Access Compliance Report Public Rights-of-Way (Curb Ramps)

Main Street: N/A		Cross Street: DORRANCE_DR		Location:	NE
ADA ID: RPRK220223150055	Ramp Type: Type 4 - Parallel	Initial Pass/Fail: Fail	Overall Compliance: No	Severity Score:	16

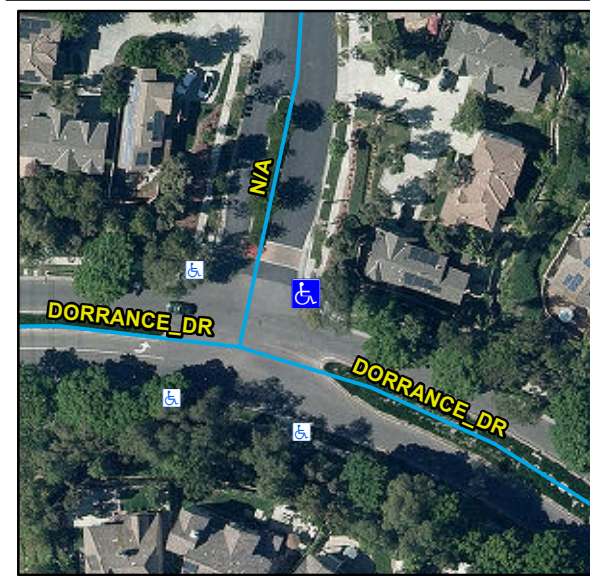
Compliance	Description	Data	Compliance	Description	Data
N/A	Ramp Length LT (in)	135	N/A	Ramp Length RT (in)	132
Yes	Ramp Width LT (in)	89	Yes	Ramp Width RT (in)	89
Yes	Ramp Run Slope LT (%)	1.3	No	Ramp Run Slope RT (%)	9.3
No	Ramp Cross Slope LT (%)	3.3	Yes	Ramp Cross Slope RT (%)	0.5
N/A	Landing Present	N/A	N/A	DWS Provided	N/A
N/A	Landing Length (in)	N/A	N/A	DWS Contrast	N/A
N/A	Landing Width (in)	N/A	N/A	DWS Length (in)	N/A
N/A	Landing Run Slope (%)	N/A	N/A	DWS Full Width	N/A
N/A	Landing Cross Slope (%)	N/A		DWS Offset Type	N/A
N/A	Landing Movement Obstructed?	N/A	N/A	DWS Offset Left (in)	N/A
	Landing Movement Type	N/A	N/A	DWS Offset Right (in)	N/A
N/A	Landing Shared	N/A			
N/A	Clear Space	Yes			
N/A	Clear Space To Crosswalk (in)	48			
N/A	Marked Crosswalk 1	No	N/A	Marked Crosswalk 2	No
	Crossing 1 Direction	W		Crossing 2 Direction	S
N/A	Marked Crosswalk 1 Width (in)	N/A		Marked Crosswalk 2 Width (in)	N/A

N/A	Ramp Inside Crosswalk 1	N/A	N/A	Ramp Inside Crosswalk 2	N/A
	Crossing 1 Slope (%)	3		Crossing 2 Slope (%)	1.4
	Crossing 1 Cross Slope (%)	3		Crossing 2 Cross Slope (%)	4.4
N/A	Gutter Ponding	N/A	N/A	Curb Slope	1.8
Yes	Gutter Lip Height (in)	0		Road Run Slope (%)	4.3
N/A	Gutter Run Slope (%)	N/A		Road Cross Slope (%)	1.6
N/A	Gutter Cross Slope (%)	N/A	Yes	Perpendicular Joint Present	Yes
Yes	Overall Surface Condition	Acceptable			
	Cross Gutter Present?	No		Spandrel Present?	No
	Replace Cross Gutter?	N/A		Replace Spandrel?	N/A

Remove & Replace Curb Ramp With Two New Directional Ramps or Equivalent.
